**RESPONSE TO INFORMATION REQUEST MCU/2021/718
PROPOSED WAREHOUSE DEVELOPMENT
LOT 501 VANTAGE INDUSTRIAL ESTATE YATALA**

Reference is made to the above project and Council's Request for Further Information, dated 28 January 2022. We have been engaged to address Items 4 - 11 of the request in relation to Transport Assessment. Our responses are provided as follows:

ATTACHMENT A – B99 TURNING

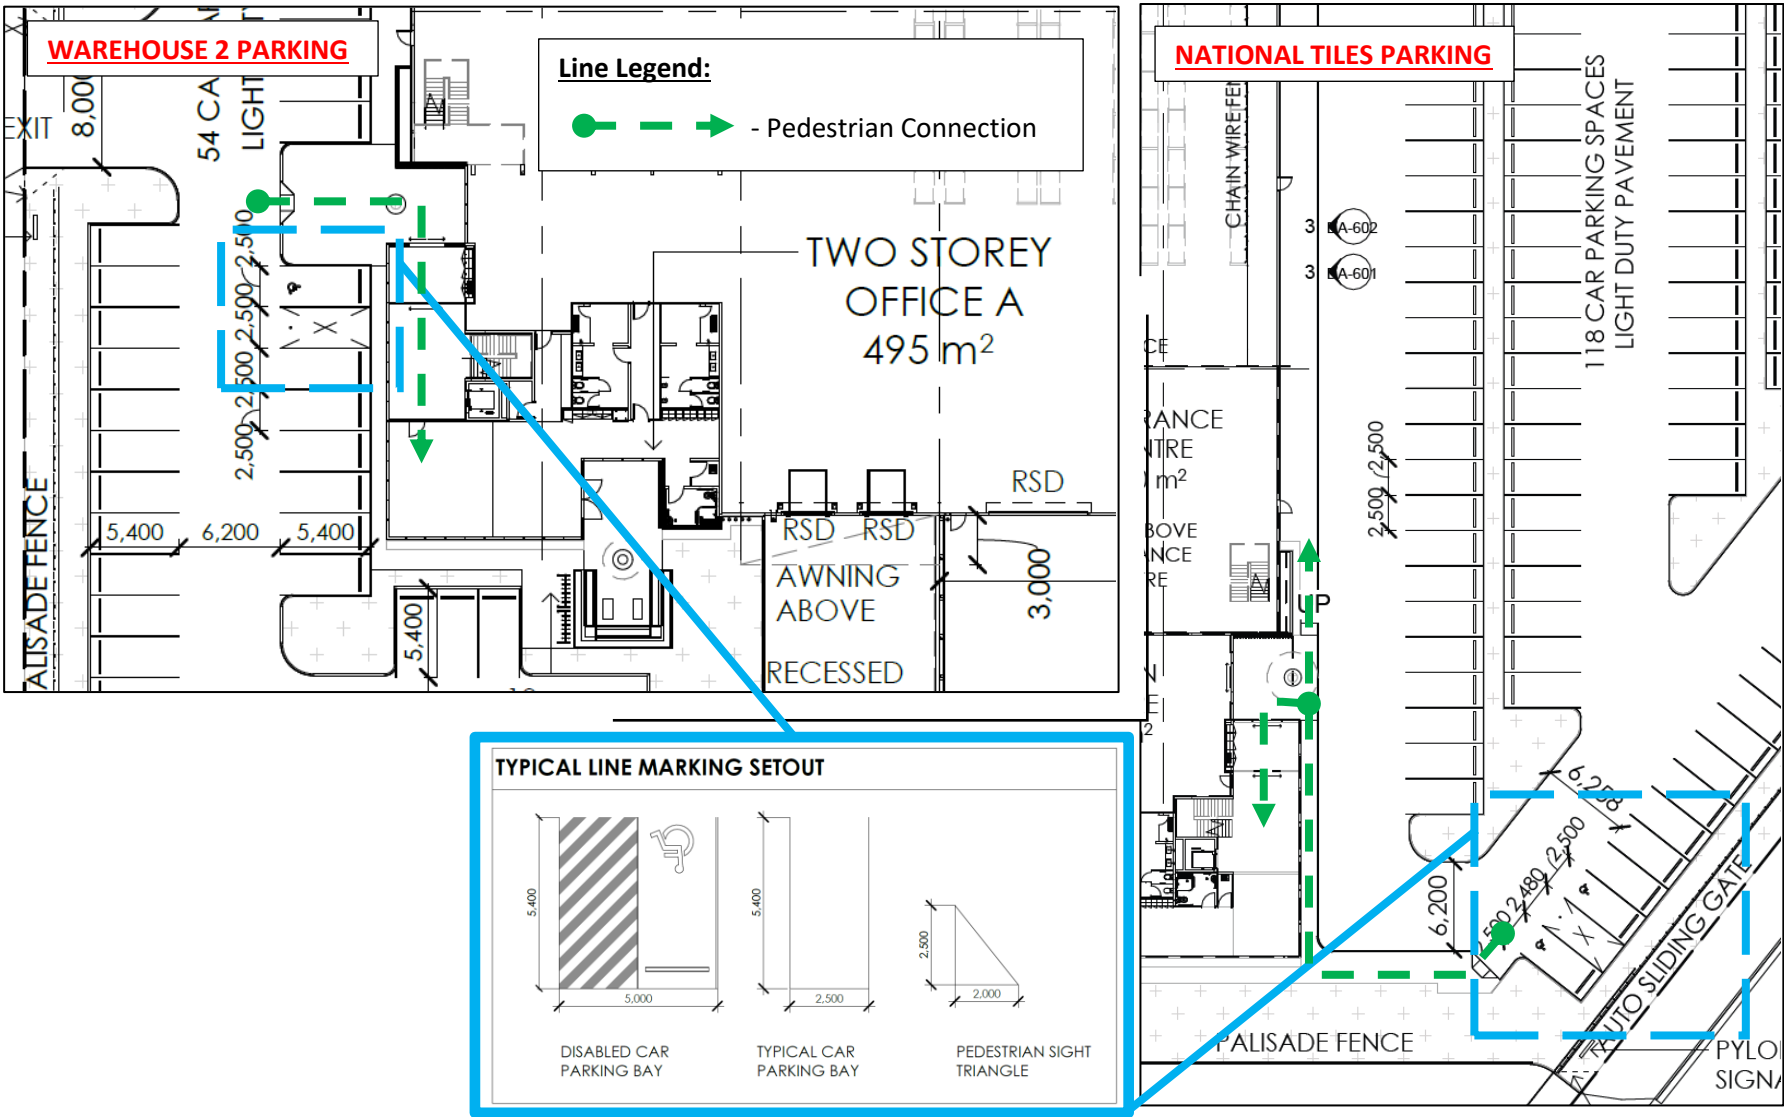
Pursuant to AS50.1 (a) of the M38 Industrial Place Code, internal driveways must be designed and constructed to enable all vehicles to enter and exit the site in a forward motion. The applicant is requested to update the drawings to include turnaround bays at the end of parking aisles in the parking area for Warehouse A.

As shown in Attachment A, should visitor parking be fully occupied, a vehicle can turn within the aisle near the entry, as well as at the southern end of the car park in order to exit the site in a forward gear. This is considered to be satisfactory given the low probability that all visitor spaces would be occupied on the basis that no showroom or facilities that would attract visitors are provided at the tenancy.

Based on the above, it is therefore considered that a turning bay is not necessary.
